**1.4 17-31 FRANKLYN STREET, HUNTINGDALE
USE AND DEVELOPMENT OF THE LAND AS WAREHOUSE, STORE, OFFICE AND
FOOD AND DRINK PREMISES
(TPA/53506)**

EXECUTIVE SUMMARY:

This application proposes the construction and use of eight (8) buildings for the purpose of warehouse, storage units, office tenancies and food and drink premises, together with associated car parking.

East elevation provided by Applicant

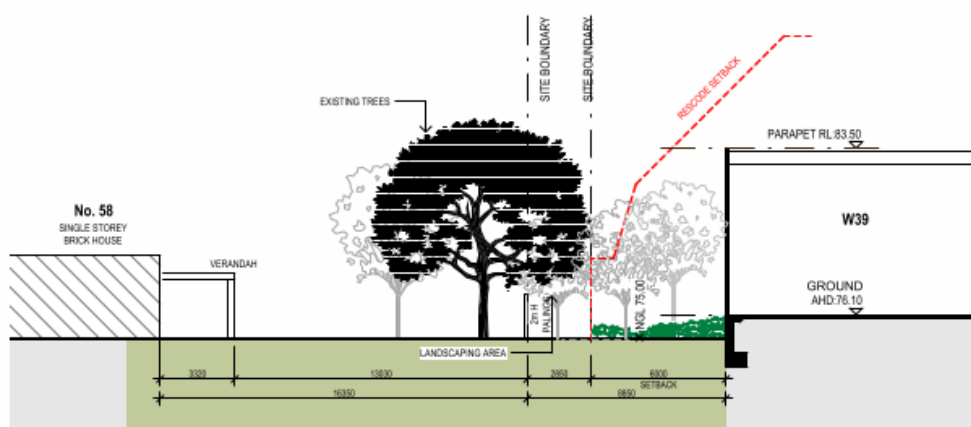
The building façades are articulated through the use of a variety of materials and finishes to provide visual interest and to break down the length of the façades. The proposal utilises a pattern of projecting and recessive elements to the façade of Building B along Franklyn Street to break up the length of this façade along the street frontage. The façades provide for good level of visual interest appropriate to the overall massing of the development and overall, combined with the landscaping across the frontage, will be a significant improvement to the street to that presently provided on site. The proposal will also provide passive surveillance across the entire frontage with windows facing the street.
